**Belle Isle Athletic Shelter
HVAC and Fire Protection Improvements**

751/24078.SMD

Addendum 1

8.28.2025

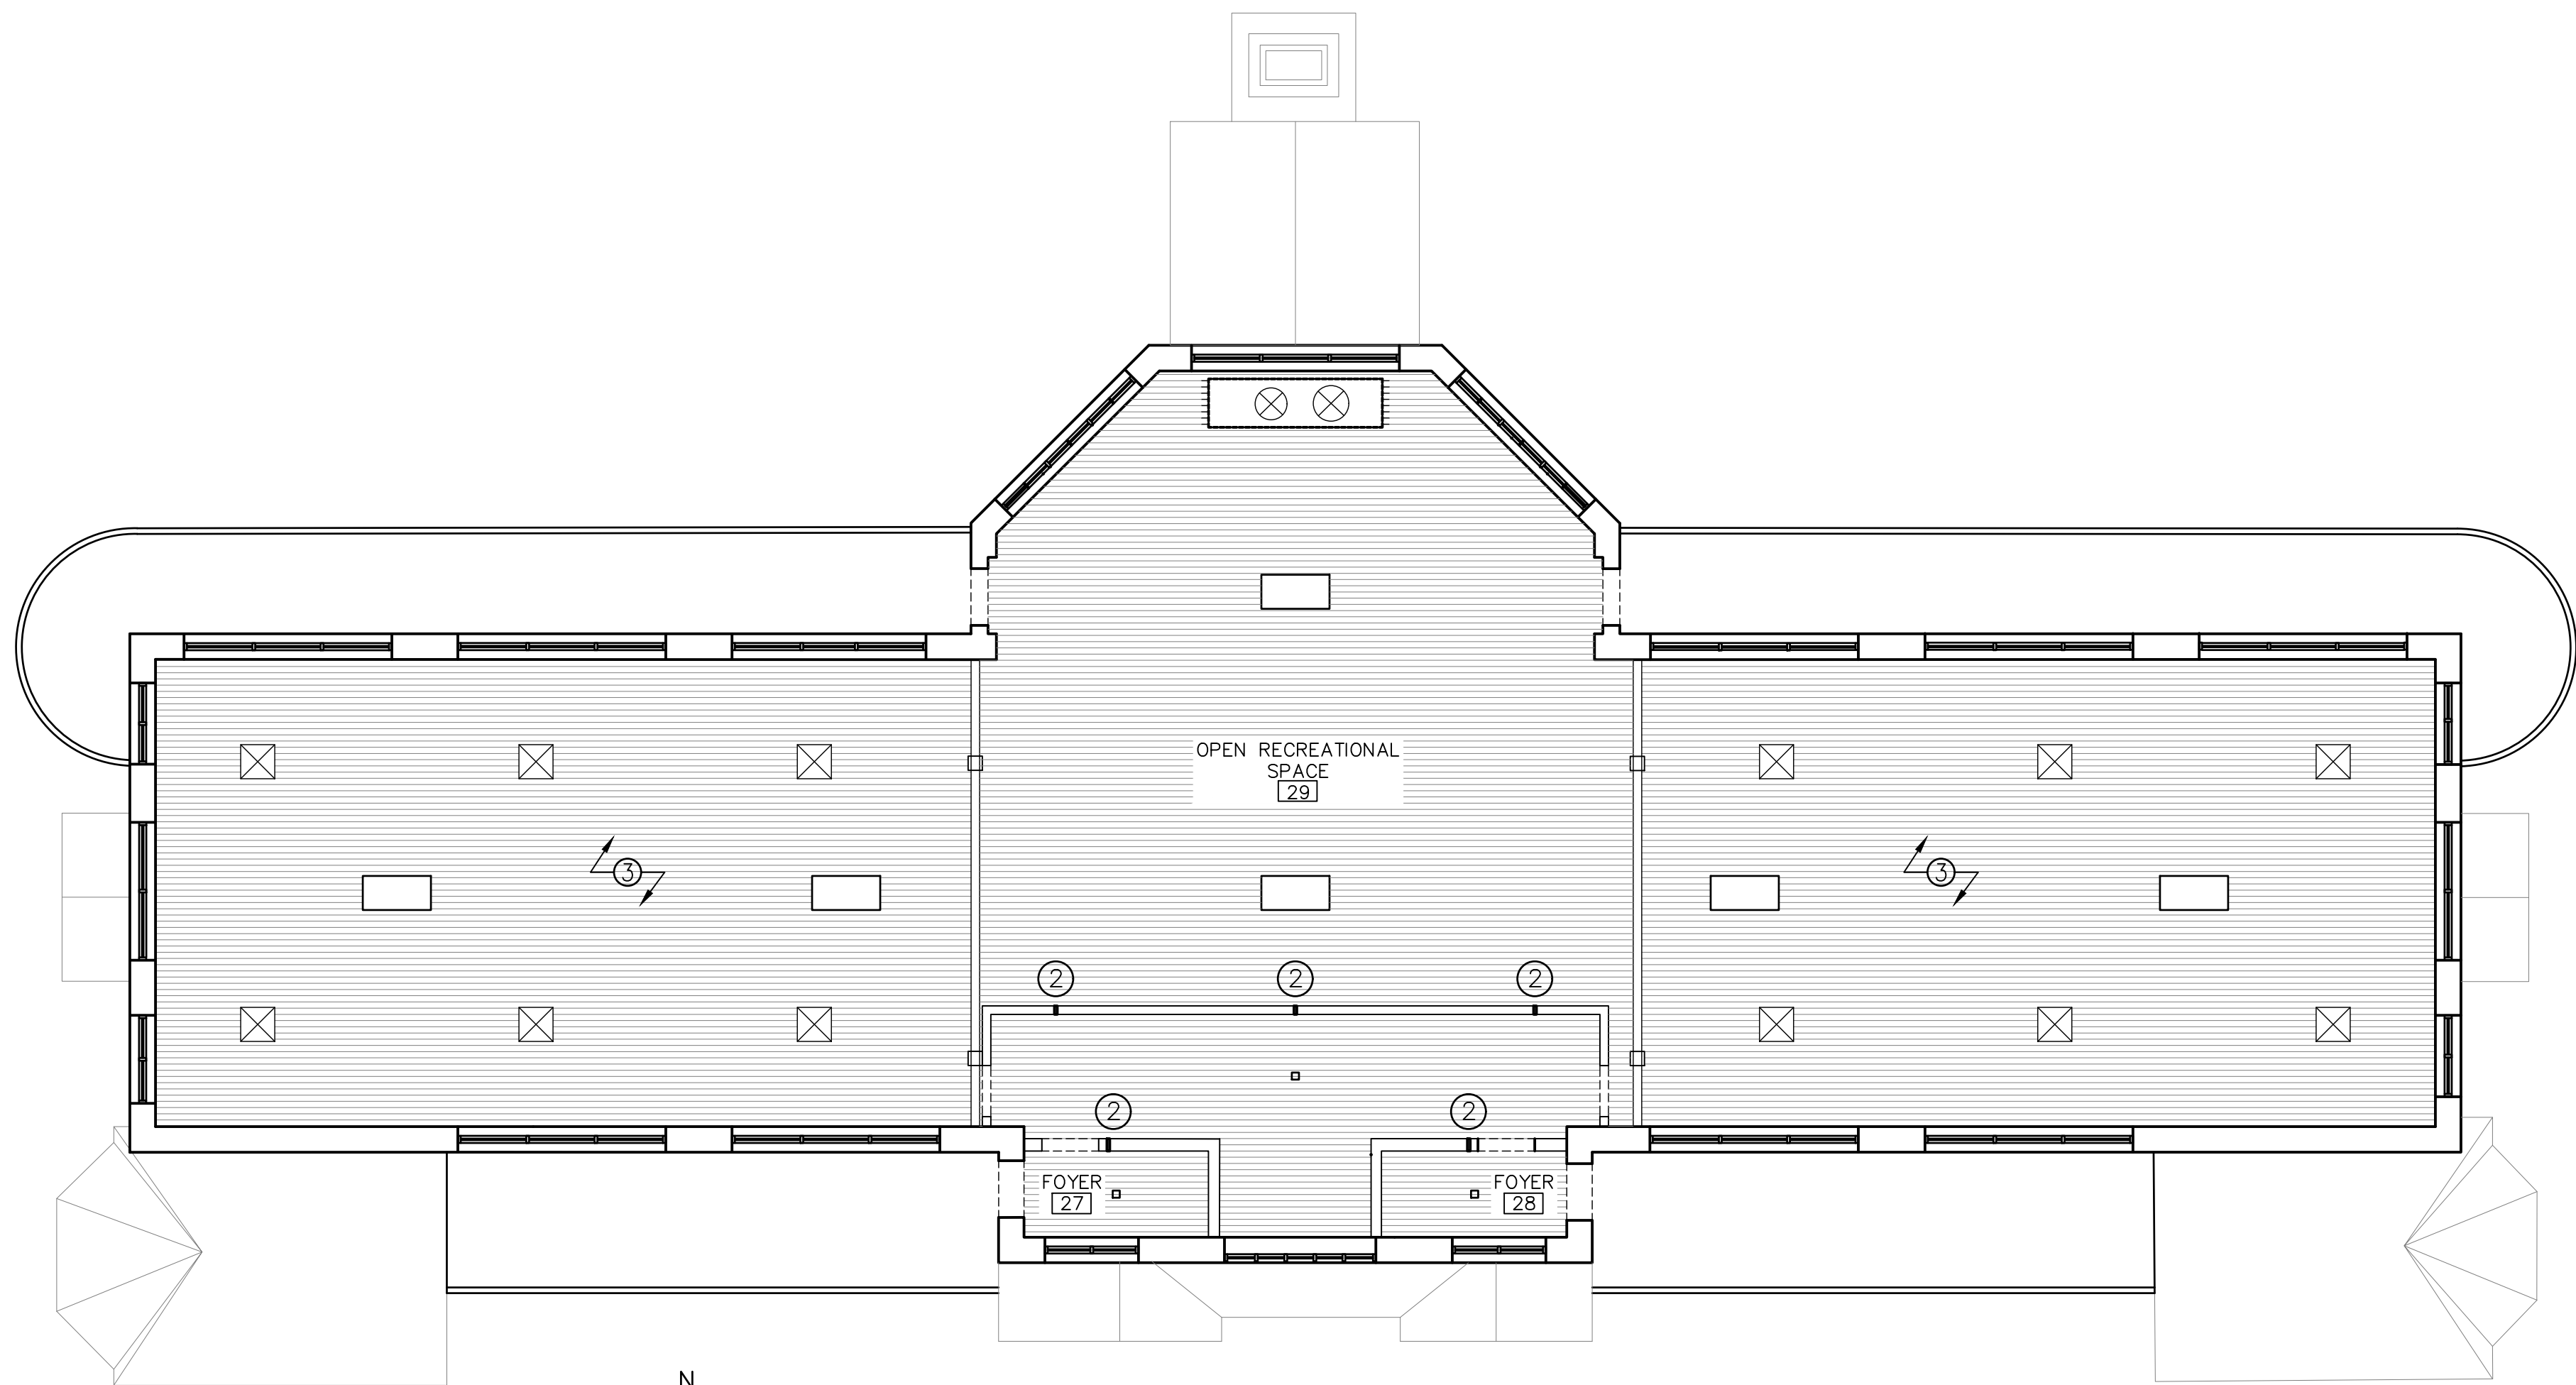
- a. Staging and dumpster area noted. Temporary Fence and signage to be provided at entrance to parking lot.
- 2. AD-102:
 - a. Add removal of wood panel at stair.
- 3. A-102
 - a. New prefinished insulated metal panel where wood panel is removed.

- ① NEW 1-HR FIRE RATED GYP BD AND METAL STUD WALL FOR NEW DUCT RISER SHAFT IN EXISTING LOCATION. CONFIRM DIMENSIONS WITH ARCHITECT ONCE SHAFT IS OPENED. SHAFT TO ACCOMMODATE NEW SPRINKLER RISER. SHAFT WALL TO BE KEPT AWAY FROM WINDOWS AND HELD AS SMALL AS POSSIBLE. NEW RETURN GRILLE ON SHAFT FACE. SEE DETAIL 2/A501 FOR SHAFT WALL CONSTRUCTION.
- ② PROVIDE OCCUPANCY SIGN READING: MAXIMUM OCCUPANCY 49. INSTALL TO BE COMPLIANT WITH ADA. COORDINATE EXACT LOCATION WITH OWNER PRIOR TO INSTALLATION.
- ③ PROVIDE NEW GLASS FOR WINDOW TO BE VERIFIED IN FIELD. ⚠
- ④ PROVIDE NEW METAL INSULATED PANEL. VERIFY SIZE IN FIELD.

1
AD-102
N
SECOND FLOOR PLAN –DEMO
SCALE: 1/8" = 1'-0"

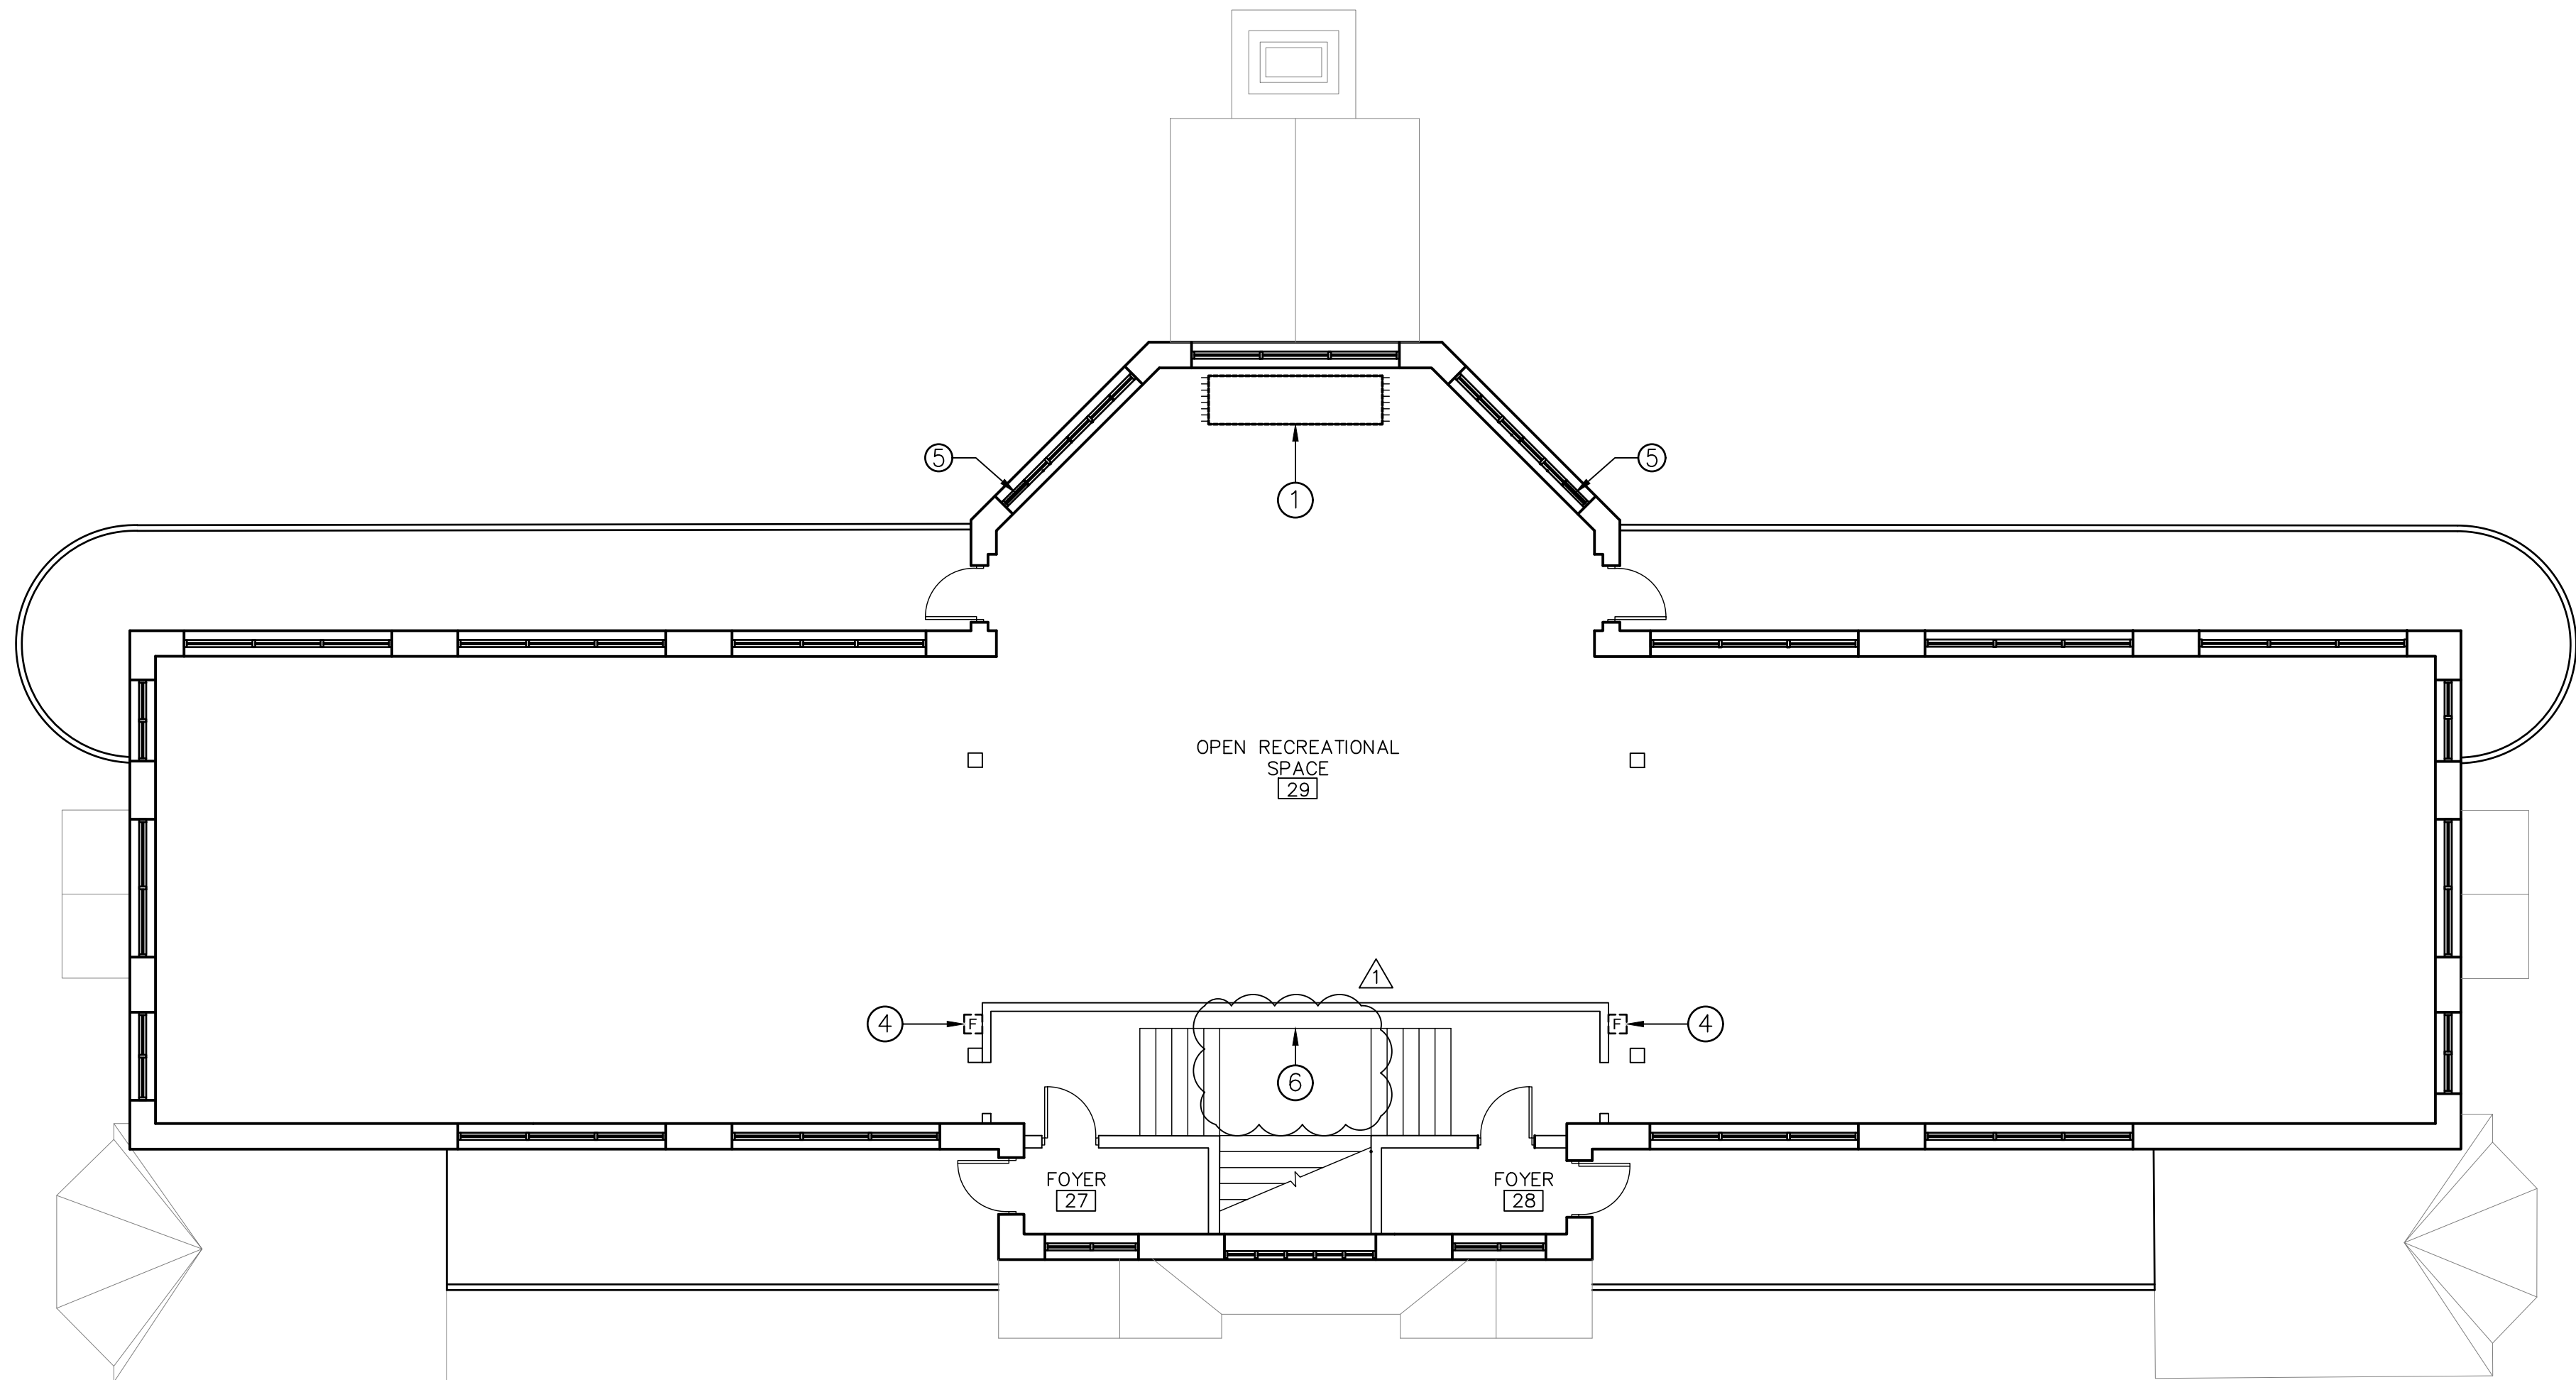
1. REMOVE EXISTING GYPSUM BOARD SHAFT ENCLOSURE. CORE CONCRETE DECK FOR NEW SPRINKLER RISER. SUPPORT DUCT RISERS TO REMAIN.
2. CORE PLASTER AND STUD WALL FOR NEW SPRINKLER PIPE- REFER TO FIRE PROTECTION PLAN.
3. FIRE EXTINGUISHERS IN THE ATTIC TO BE PROPERLY DISPOSED OF PER SPECIFICATION 02 80 00.
4. REMOVE PULL STATION. EXISTING CONDUITS TO REMAIN. PATCH CONCRETE.
5. REMOVE TEMPORARY AC VENT KIT FROM WINDOW. REMOVE WINDOW GLAZING, FRAME TO REMAIN.
6. REMOVE WOOD PANEL AT STAIRS.
